Concerns regarding the potential hydrological impacts of proposed Hallman Pit

Delegation on April 4th Special Council meeting
Township of Wilmot

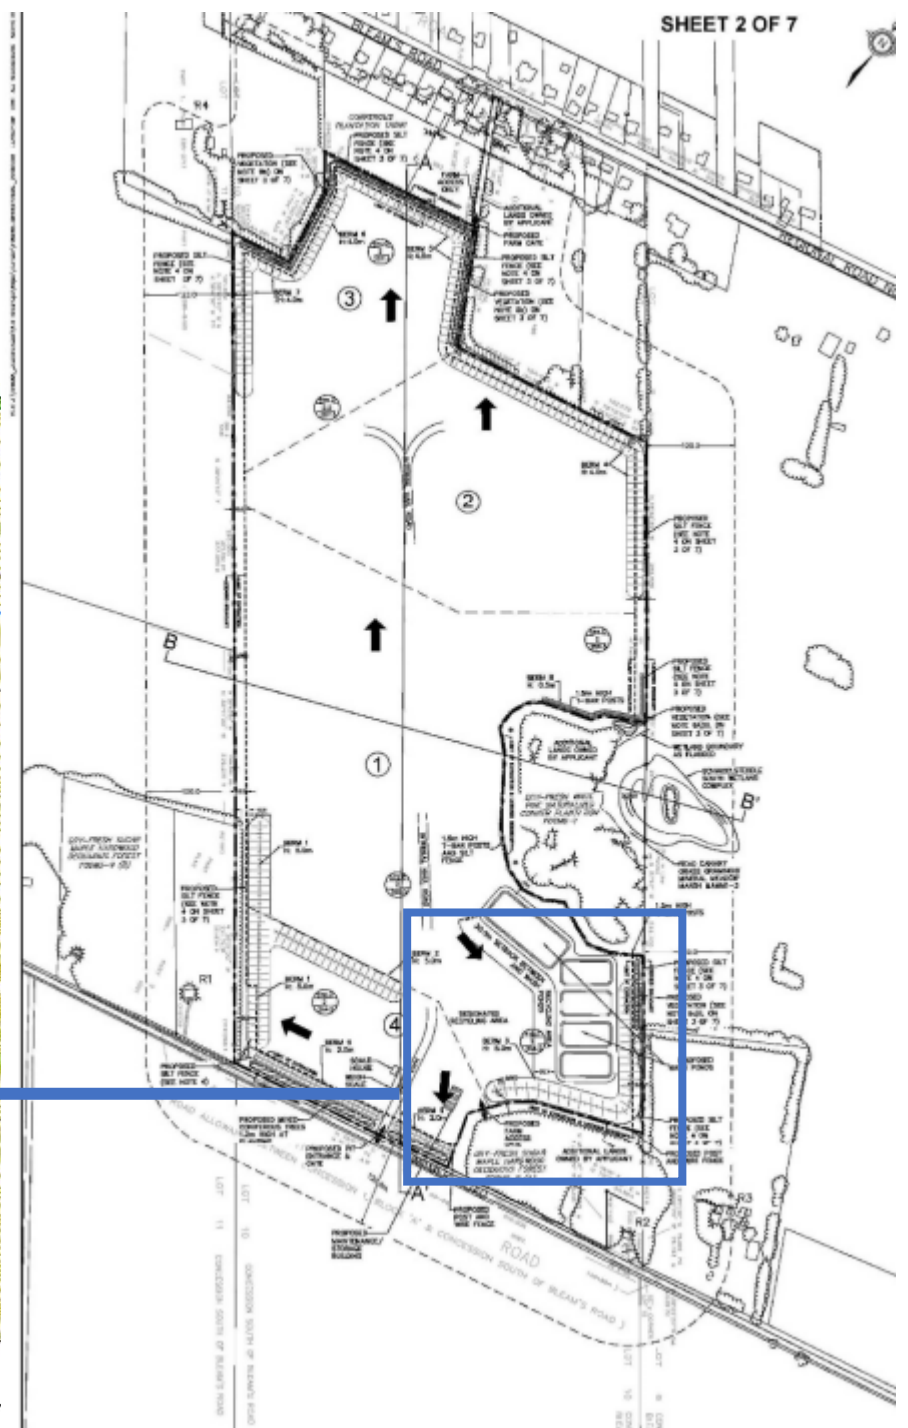
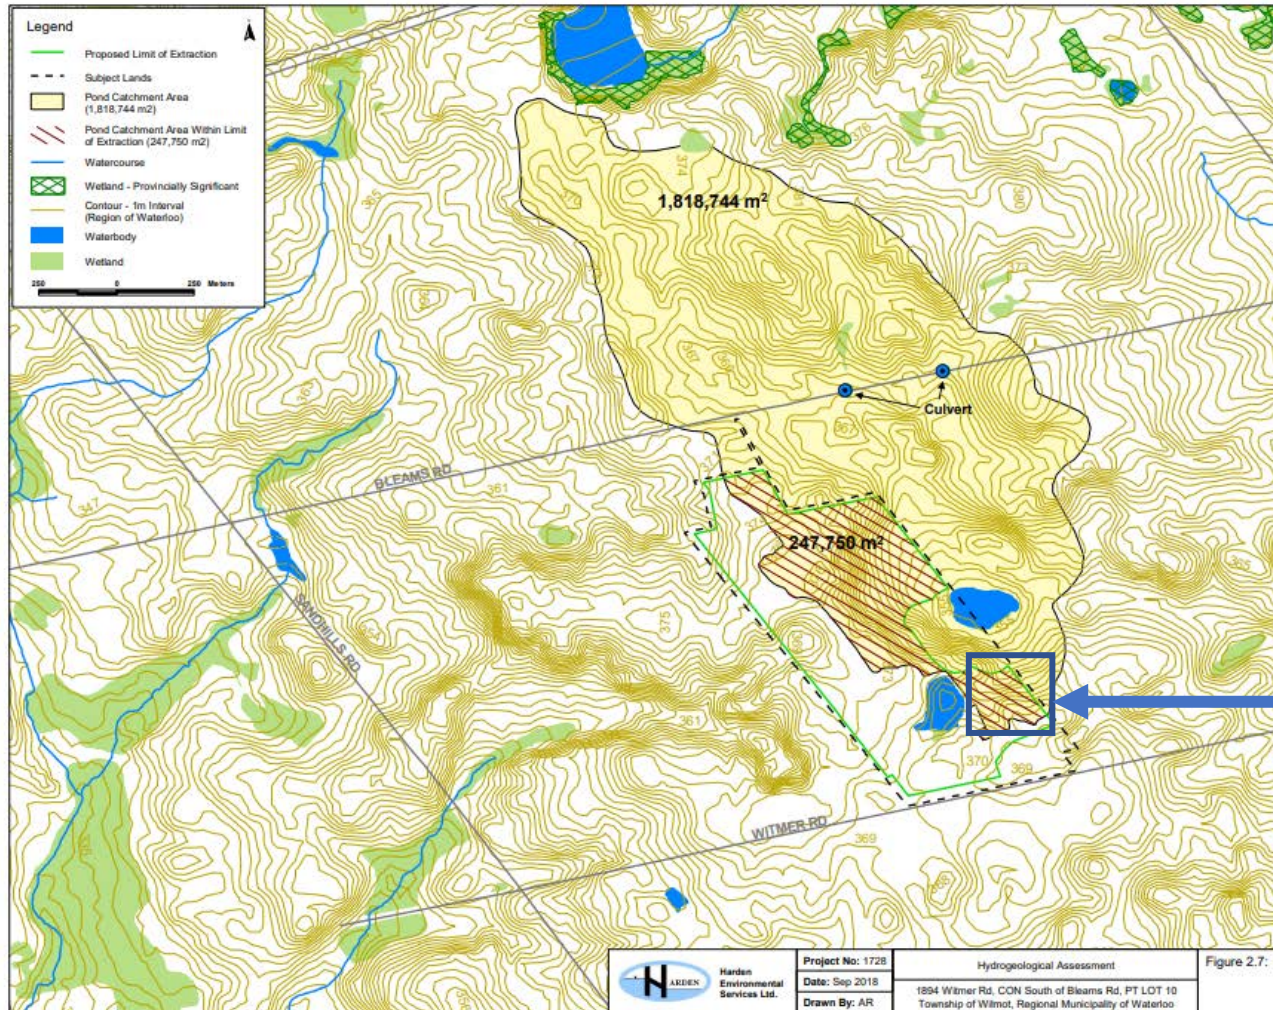
My concerns:

1. Will the net increase in water result in increase in water table level? If so, if the 1.5 m buffer zone be enough?
2. Will climate change-induced extreme precipitation further impact the level of water table?
3. Adjustment plan?
